Jackson Rancheria RV Park  
Registration Building Remodel  
Jackson, CA.

Title:  
**MECHANICAL REFLECTED CEILING PLAN NEW**

**M-3.0**

**Bid Set**  
08/27/2023

**1 MECHANICAL REFLECTED CEILING PLAN NEW**  
M-3.0 1/4" = 1'-0"

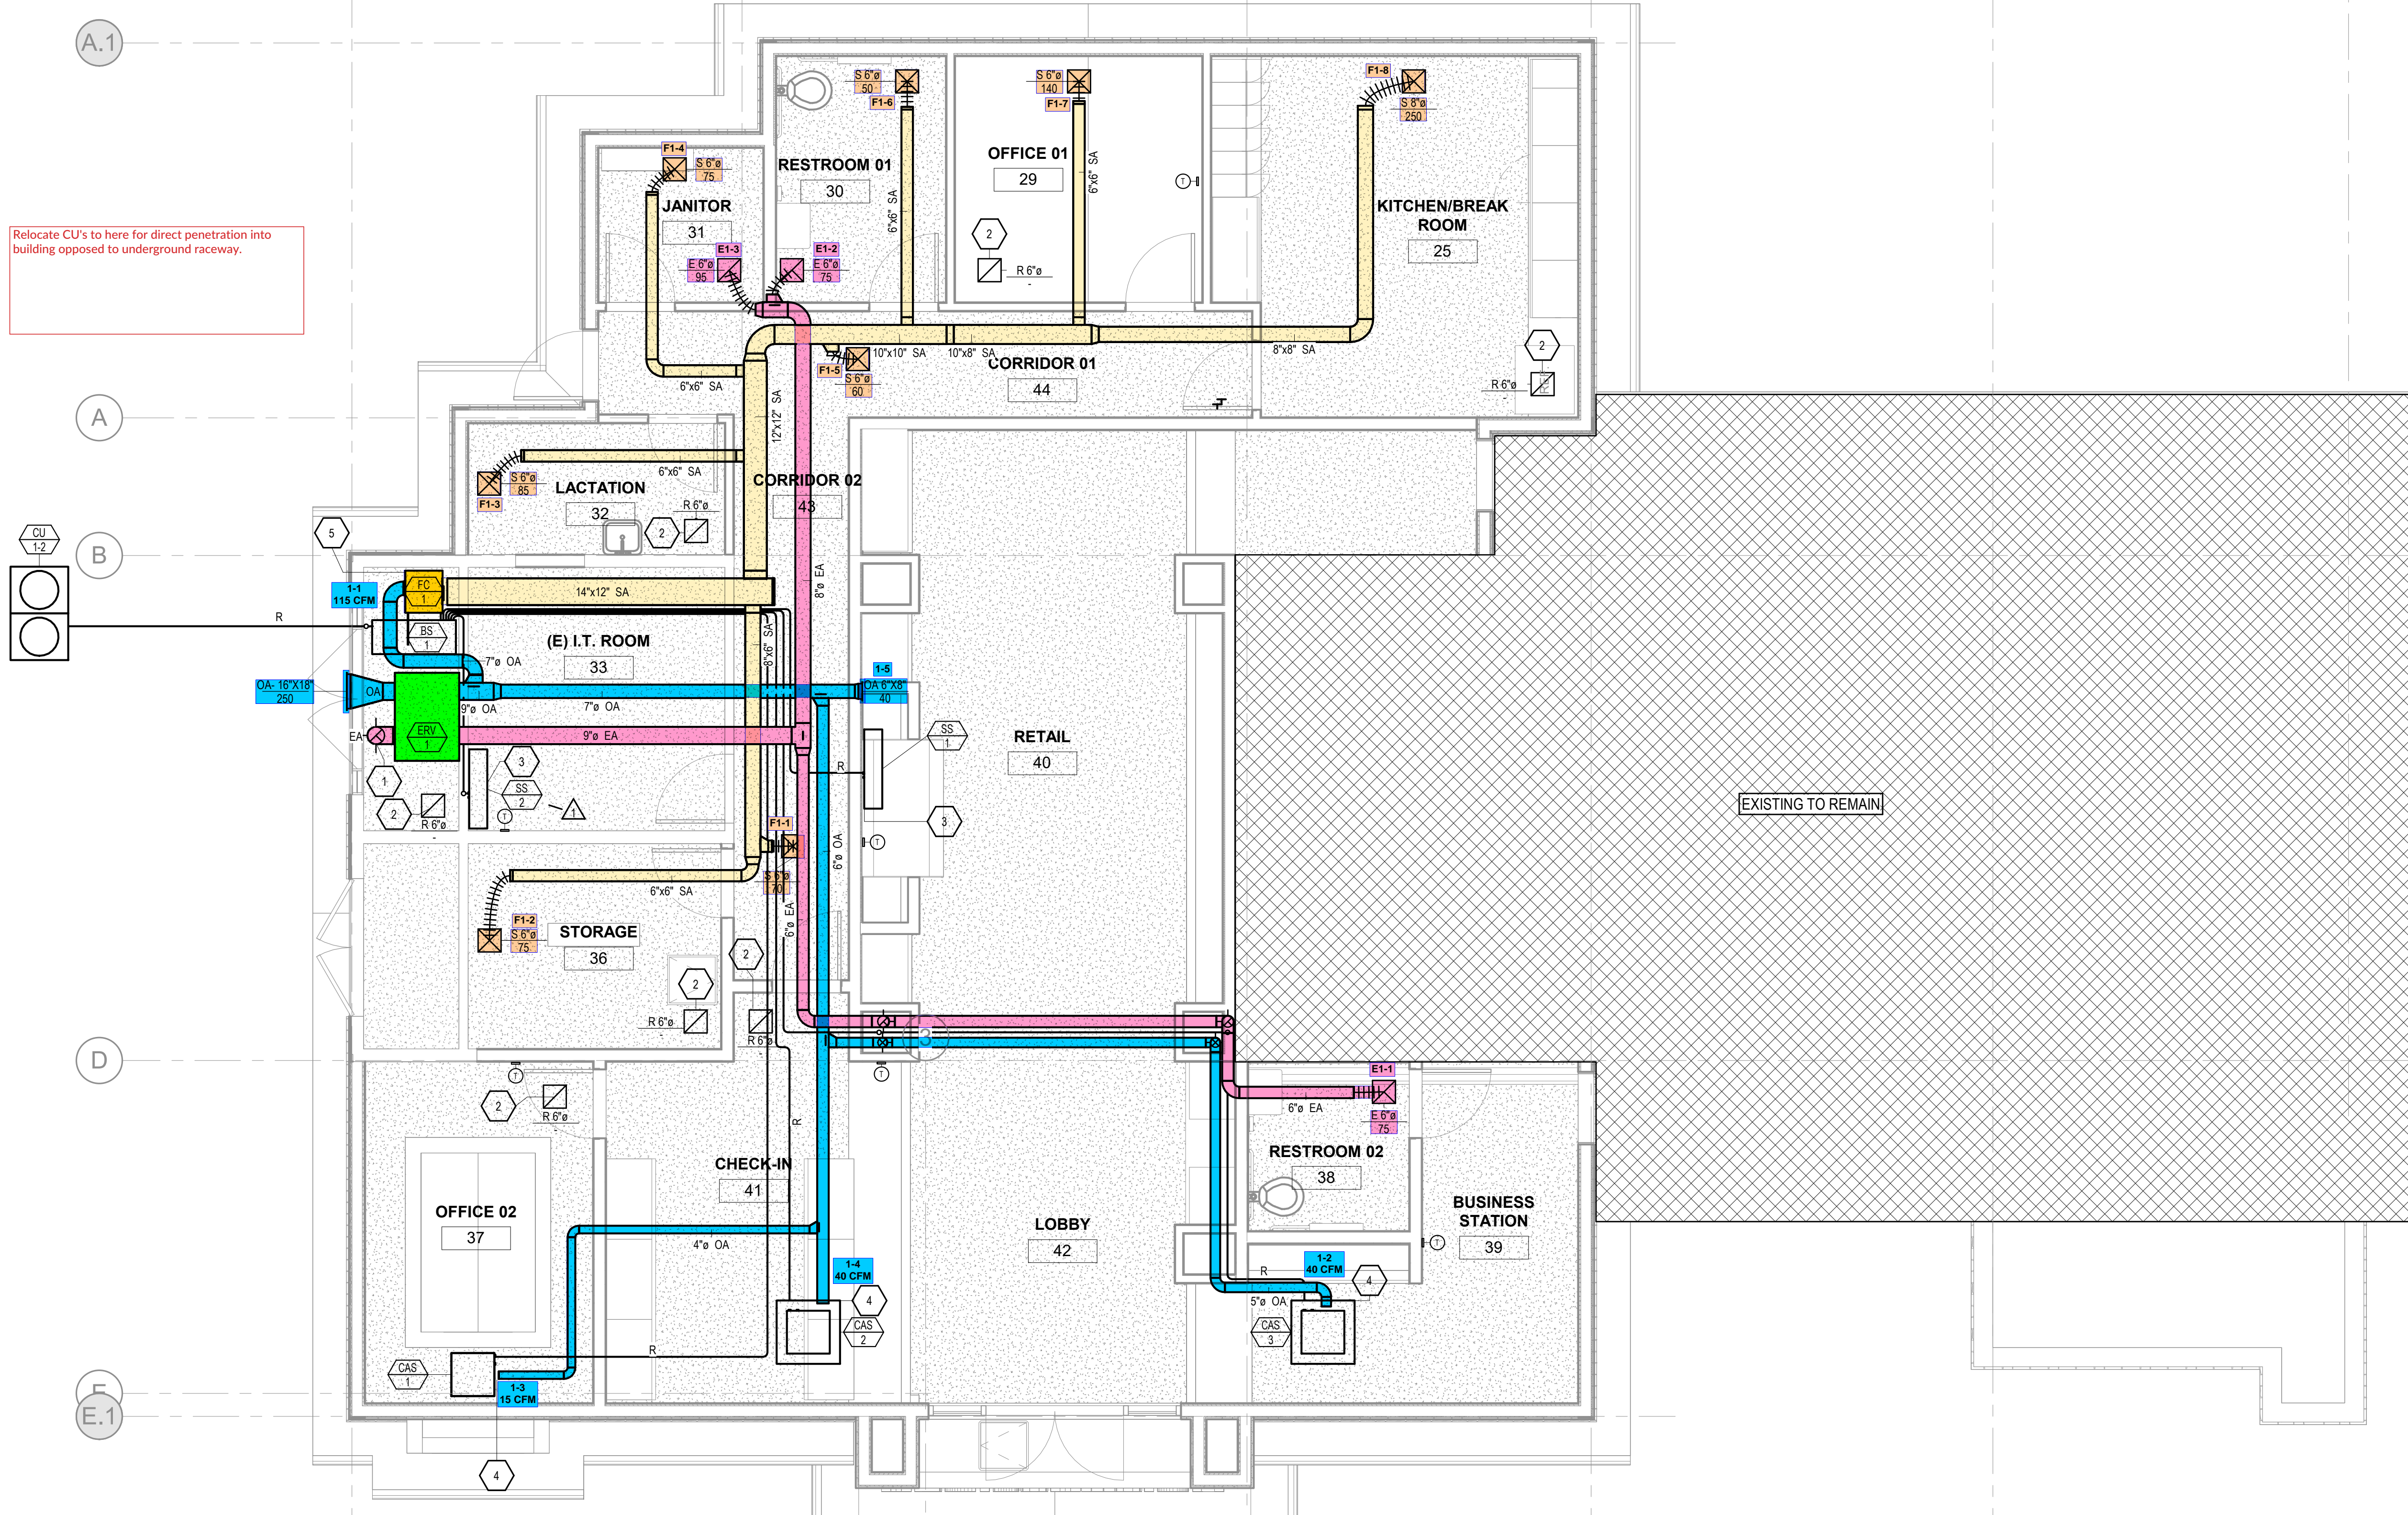
Relocate CU's to here for direct penetration into building opposed to underground raceway.
